# UNITED STATES PATENT AND TRADEMARK OFFICE

APPLICATION NO.	FILING DATE	FIRST NAMED INVENTOR	ATTORNEY DOCKET NO.	CONFIRMATION NO.
10/074,362	02/12/2002	Brian N. Tufte	1076.1101106	9078

# Office Action Summary

Part of Figure 38 of the instant application (a) and Figure 4 of Newman (b). Newman's figure has been modified to designate elements corresponding to those of the claimed invention using the same reference numbers used by the applicant.

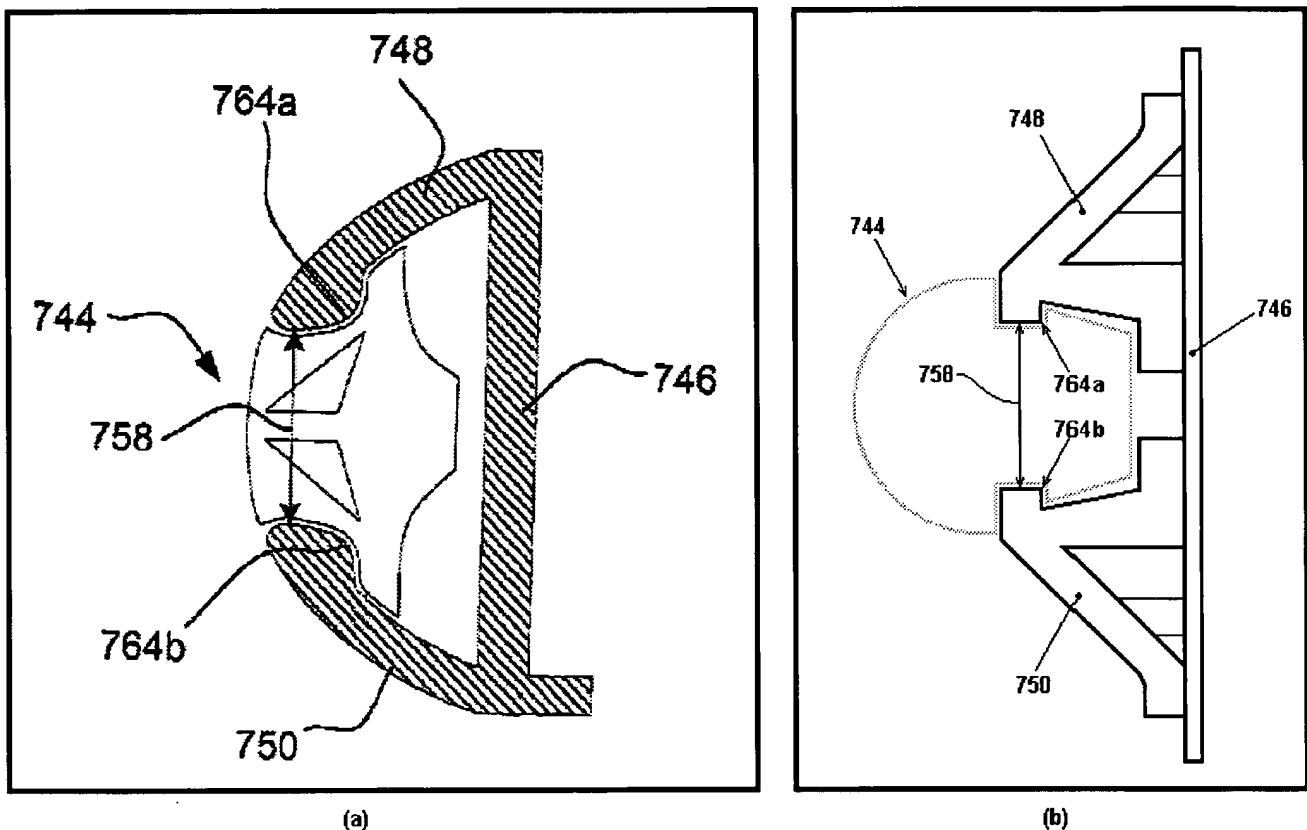
9. Regarding the Examiner's rejection of claims 1, 11 and 14 under 35 U.S.C. 102(b), the applicant argues that the cited reference fails to disclose all the features of the claimed invention, specifically the two terminating ends defining the slot, as well as an inwardly extending nub.

To clarify the Examiner's interpretation of Newman the applicant is advised to study Figure 4 of Newman in view of applicant's own Figure 38. For applicant's convenience the Examiner has modified the cited figures to show only the relevant

by the applicant. As it is evident, both applicant's Figure 38 and Newman's Figure 4 show a bumper member (744) and a carrier (742) having a pair of supporting legs (748 and 750). The supporting legs having nubs (764a and 764b) located at each end. A slot (758) is defined by the ends of the supporting legs. The only difference between both structures is the use of rounded edges by the applicant, as opposed to Newman's rather square edges.
